FIRE SAFETY INSPECTION REPORT

W APPARELS

ACCORD
on Fire and Building Safety in Bangladesh

March 23, 2014

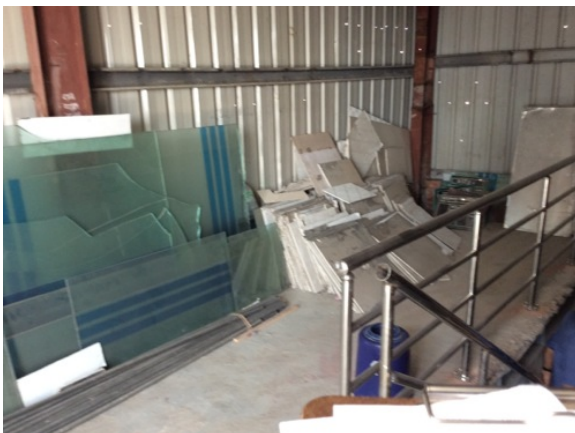
F-6	Egress	Egress doors / gates with locking features are provided at all stair openings on 1st-3rd floors, and exit discharge.	Remove locking features from all egress doors / gates. If locks are required for security reasons, utilize special door locking features complying with NFPA 101.	Immediate
-----	--------	--	--	-----------
